OFFICE VISIT
F & M SCIENTIFIC CORP.
AUGUST 15, 1963

TRITIUM LOSS PER 24 HRS / TEM FOR 200 MC H₃
STAINLESS STEEL FOILS

TELEPHONE CALL FROM J. PETERS
F & M SCIENTIFIC CORPORATION
JULY 25, 1963

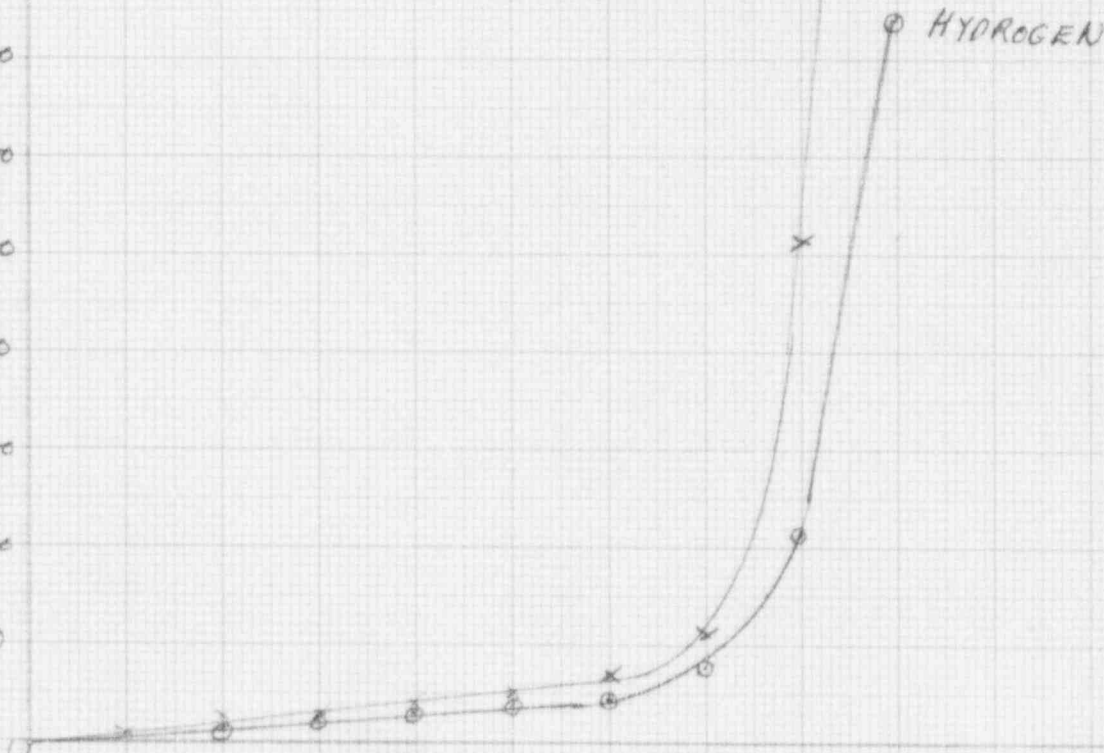
A curve of tritium loss versus temperature was presented to supplement a similar curve submitted with their original proposal describing their detector cells. However, the other item of additional information which we had requested by telephone was not furnished. Mr. Peters stated that they would send us this information in the form of a verbal description of the outer cabinetry used to protect and secure the detector cells.

It was stated by Messrs. Peters and Smith that their latest curve was based on the use of both "old" foils and new foils that they had obtained from a foil that had been in use several months, that all foils were of the ^{nominal} ~~nominal~~ 1 curie per square inch ^{type} and that the gases used were directly from the container. Although the gases were not dry ^{sec} prior to their use, it was not known what amount of moisture was contained in the gases.
